UNITED STATES PATENT AND TRADEMARK OFFICE

| APPLICATION NO. | FILING DATE | FIRST NAMED INVENTOR | ATTORNEY DOCKET NO. | CONFIRMATION NO. |
|--|-------------|----------------------|---------------------|------------------|
| 10/091,788 | 03/06/2002 | Qing Chen | AINNO.0104 | 8949 |

| Office Action Summary | Application No. 10/091,788 | Applicant(s) CHEN ET AL. | |

DETAILED ACTION

Feature claimed

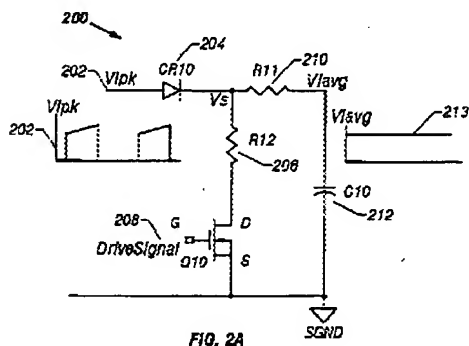
The only difference between Hirst and the invention claimed is that the claim recites the resistor coupled to the cathode of the diode in place of the resistor coupled to the anode of the diode.

It would have been obvious to one of ordinary skill in the art at the time the invention was made to couple the resistor to the cathode of the diode instead of coupling to the anode as taught by Hirst because coupling the resistor before or after the diode (i.e. couple the resistor to anode or couple to cathode) the function of the circuit does not change since the current, either being rectified (Resistor couples to the cathode) or not (couple to the anode), flows through the switch and will be modulated to obtain desired results.

Prior art applied in the rejection

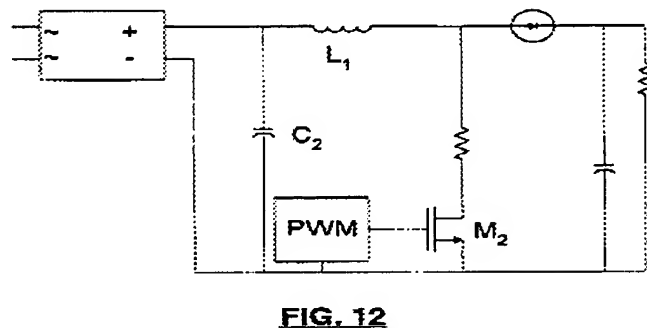
Regarding claim 1, Hirst discloses a device comprising (Figure 12) (a) a diode; (b) a resistor in series with a switch (M2), with the resistor coupled to the diode; (c) an RC filter in parallel with the resistor and switch of element (b).

Regarding claim 2, Hirst discloses the switch (M2) is synchronized with an incoming peak current signal (PWM).

Regarding claim 3, Hirst discloses an average current signal (See also figure 10; figure 13, column 13, lines 35-39) is sensed across a capacitor (Current is sensed through the shunting resistor paralleling with capacitor on the right hand side of M2).

Regarding claim 4, Hirst discloses the RC filter (Capacitor and resistor parallels in the right hand side of the resistor and switch M2) smoothes an average current signal (The smoothing current signal is true not only for the prior art of Hirst but also true for every prior art having filter).
